Field Remedy: 1407

Subject:	Engine Lid Striker Pin - Lid opening Problems
----------	---

Models:		Engines:	Option:
Speedster 2000	2001,VX220 20002001	Z22SE,Z22SE	
Complaint:	The engine lid cannot be opened.		
Cause:	In case of heat distortion or maladjustment, the latch is misaligned and the lid cannot be opened.		
Production:	As of VIN W0L0EAR971N00	0938 all cars have	modified striker pin.

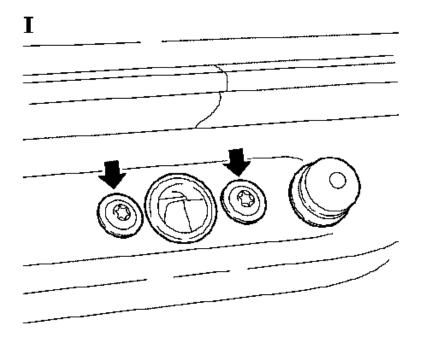
1. Remove the mounting plate (2 tightening screws) (picture I, arrows).

II

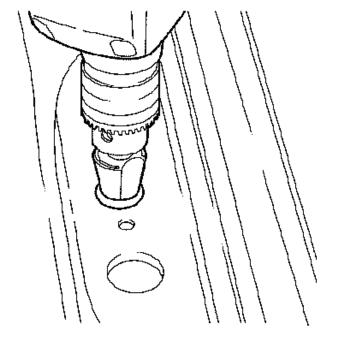
2. Enlarge the mounting hole to approximately 35 mm (picture II).

Rework the bore with a paint stick.
Invert the switch on the mounting plate and position 4 spacer washers

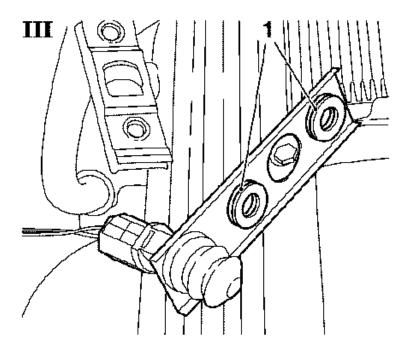
over the fixing holes (picture III, 1) in order to compensate for the inverted mounting plate flanges.

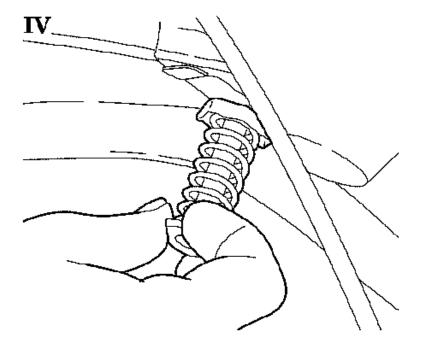
- 5. Install the mounting plate.
- 6. Remove the lid striker pin (picture IV).

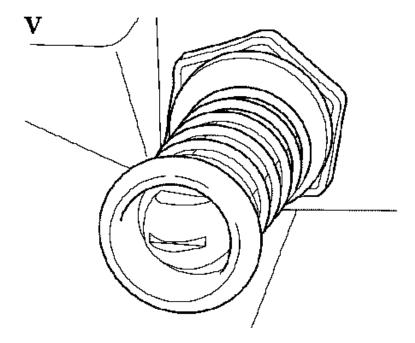
7. Install new lid striker pin with flat washer at top of spring and apply graphite grease (picture V).

The flat sides of the lid striker pin must face the driving direction.
